SUNDRY NOTICES AND REPORTS ON WELLS

| 4. Location of Well (Footage, Sec., T., R., M., or Survey Description) 790' fsl & 790' fwl (sw sw) Section 5, T25N, R8W | 8. Well Name and No. Custer Federal #1 |

Plug & Abandon Procedure

Proposed Wellbore Configuration

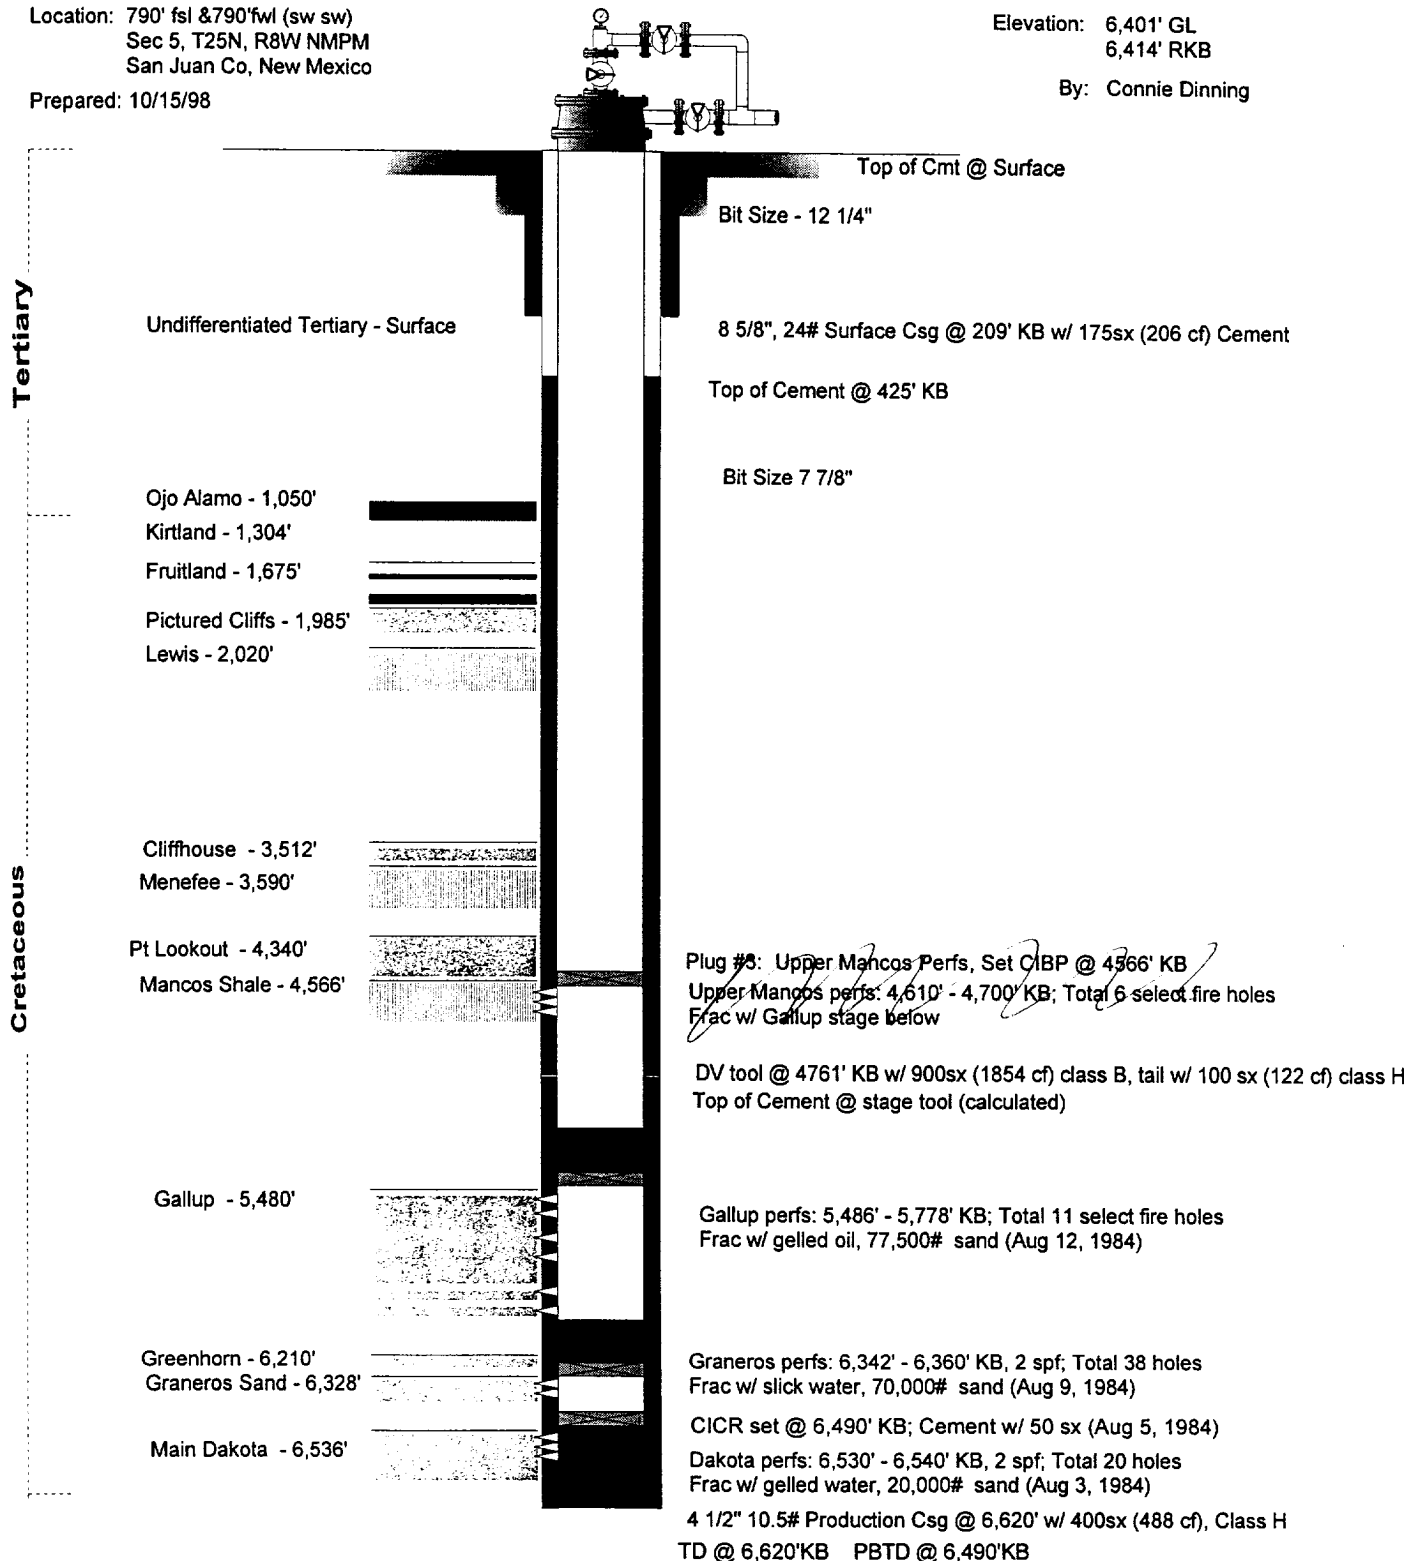
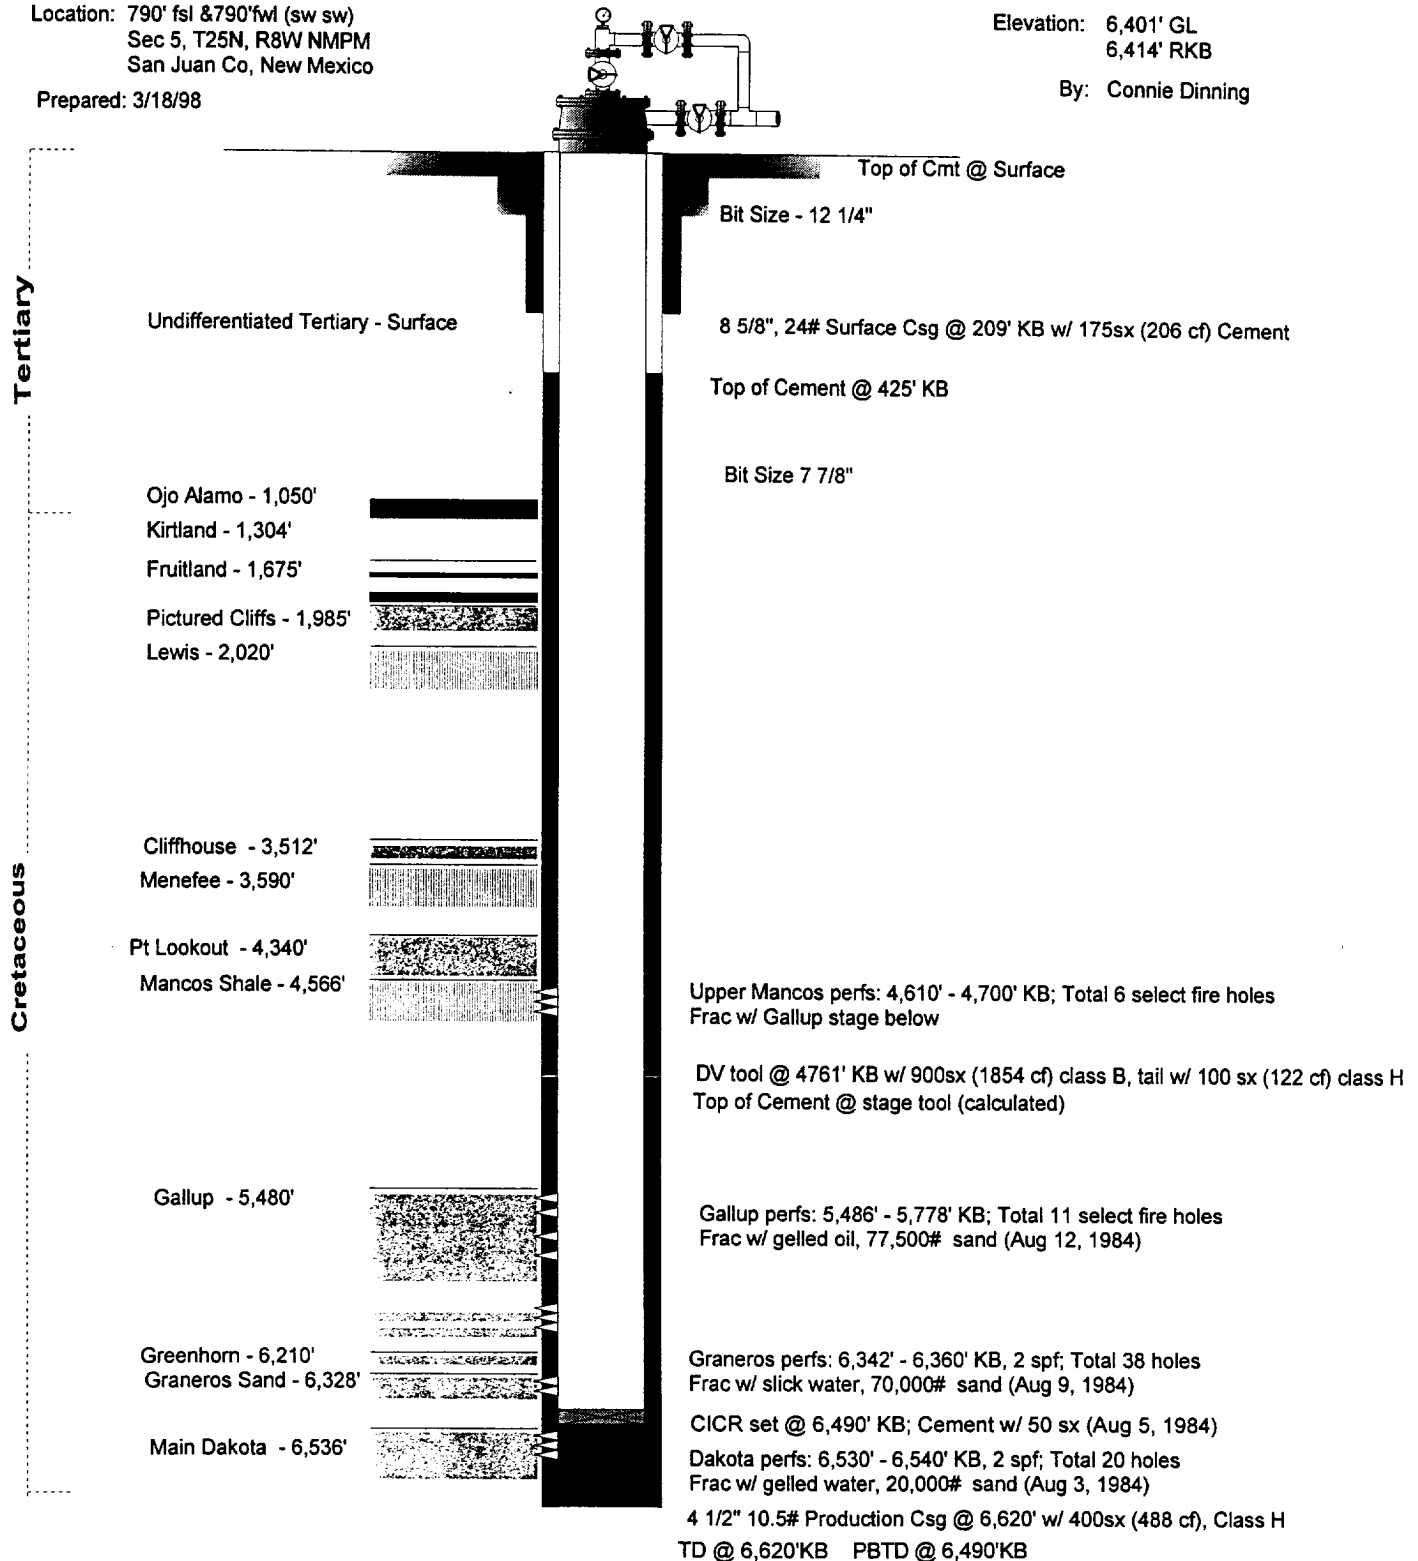
Shut-in
Merrion Oil & Gas proposes to ~~Temporarily Abandon~~ the Gallup and Dakota in this wellbore. There may be potential Fruitland Coal production uphole. It is not economically feasible for Merrion to complete the coal at this time, thus we propose the ~~TA~~ status to preserve the wellbore for future production. A detailed procedure is attached.
SZ

1. Comply to all NMOCD, BLM and Merrion safety regulations.
2. Load casing w/ water. POH w/ tubing and RIH w/ CIBP, set @ 6300' KB.
3. Plug #1 (Graneros perforations and top @ 6328'): Mix 11 sx (13 cu. ft) Class B cement and spot 100' plug on top of CIBP. POH.
4. Plug #2 (Gallup perforations and top @ 5480'): RIH w/ second CIBP and set @ 5470' KB. Mix 11 sx (13 cu. ft) Class B cement and spot 100' plug on top of CIBP. POH.
5. Plug #3 (Upper Mancos perforations and top @ 4566'): RIH w/ third CIBP and set @ 4566' KB.
6. Circulate packer fluid and pressure test to 500 psi for 15 minutes. Notify BLM to witness pressure test and record on chart.
7. RDMOL.
